20 Dress Circle Drive Lennox Head

Proposed Duplex 18.09.2018

8.1 **DA 2018/421 - 20 Dress Circle Drive Lennox Head.DOC**

Development Application No.:	2018/421
Property Description	Lot: 115 DP: 29654, 20 Dress Circle Drive LENNOX HEAD
Proposed Development:	Demolition of existing dwelling and construction of a new two storey strata title dual occupancy – attached including carport forward of the building line
Building Classification:	2
Site Inspection Date:	28 August 2018

1 Site Plan (Proposed)
 Scale: 1 : 200

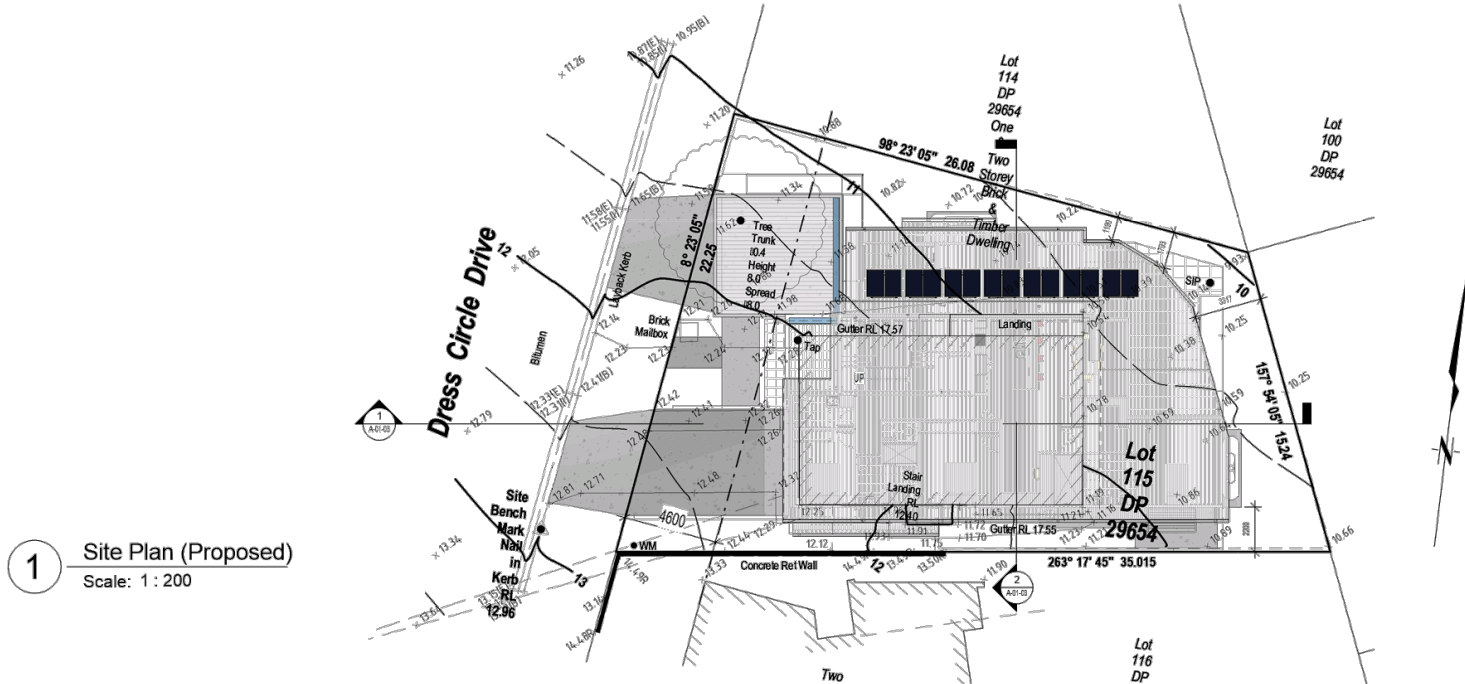
DCP Building line/articulation zone compliance (or provide comment on variation sought) (Chapter 4 DCP 2012)	<input type="checkbox"/> Yes <input checked="" type="checkbox"/> No <input type="checkbox"/> N/A
<p>Carport forward of the building line – parking for a dual occupancy is required. The applicant is proposing a double carport forward of the building line for unit 1. Carports can be located forward of the building if it meets the following controls:</p> <ul style="list-style-type: none"> • No other suitable location is available behind the setback specified in • The carport is located a minimum of 900mm from the side boundary, • The frontage facing the street remains open and is not fitted with a door or enclosing device of any kind, • The carport roof does not significantly impact on the streetscape, • The carport roof is not trafficable, • The carport does not exceed 33% of the width of the allotment frontage or 6m (whichever is lesser), and • Any side and/or rear enclosure or screening is to include minimum 50% visual permeability. <p>The site will be a vacant allotment, the applicant has justified why the variation should be permitted on the basis there is no other space on the site for parking for unit 1. This is a vacant site where the development should be designed to comply with Councils LEP and DCP.</p> <p>The double carport forward of the building line is not supported.</p>

1 West Elevation
Scale: 1 : 100

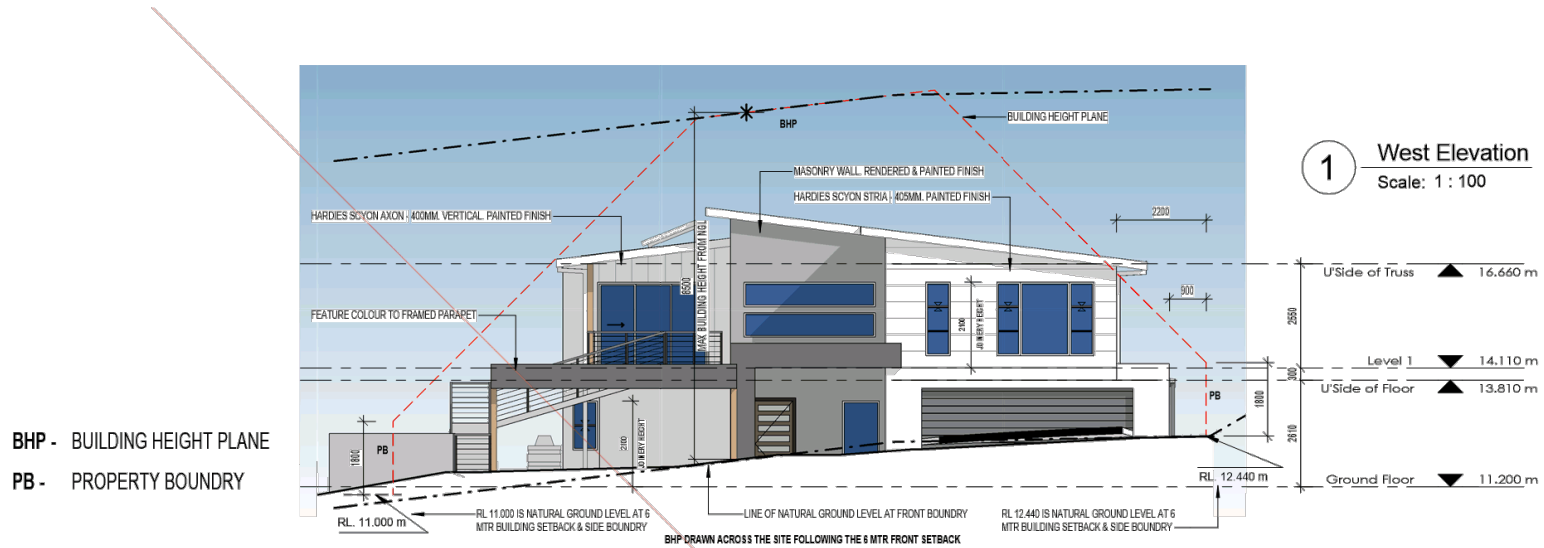
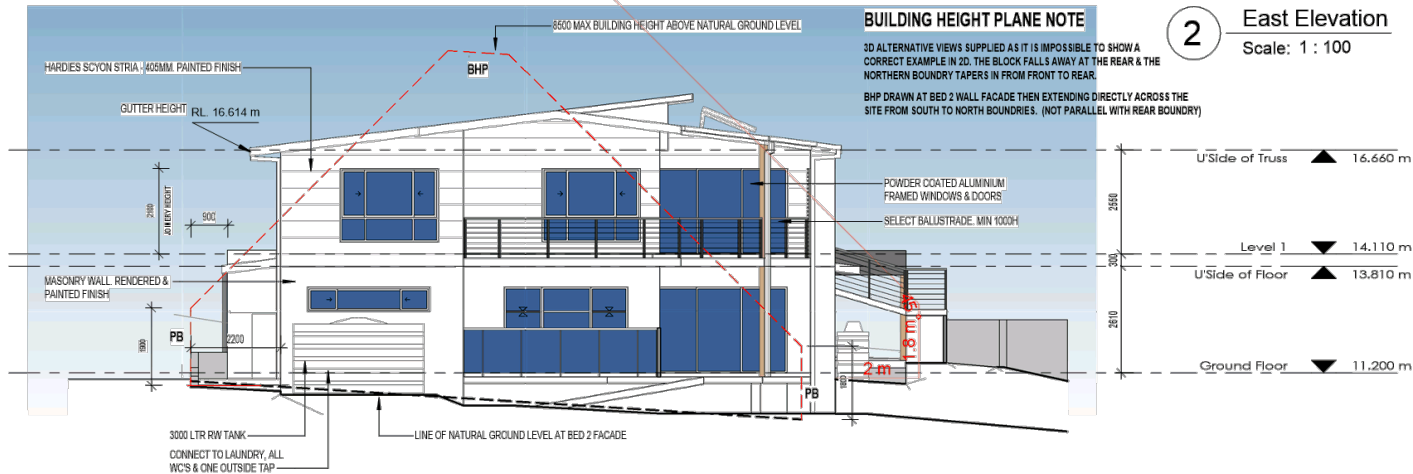
<p>Building envelope encroachment – The proposed dwelling encroaches the Building Height Plane on three elevations.</p> <p>The southern elevation overshadows the adjoining property between 9 am and 3pm on the winter solace. The living areas of the adjoining dwelling are on the upper level however due to the proposed dwelling setback of 2.2m, with no articulation of that elevation, the design will create a blank wall and cause unreasonable overshadowing.</p> <p>The objectives of this control are to ensure buildings are set back progressively from the side and rear boundaries as building height increases so that buildings do not unduly affect existing or future development on adjoining properties by way of overshadowing, impinging on privacy, or unreasonably obstructing views. This design does not comply with the above controls.</p> <p>There are BHP variations to both the northern and southern, with the variation to the north being the area of particular concern due to its bulk and scale. The proposed dwelling is setback on the northern elevation from 1m in the rear north eastern corner then gradually increases toward the front of the site.</p> <p>The building height plane variations are not supported.</p>
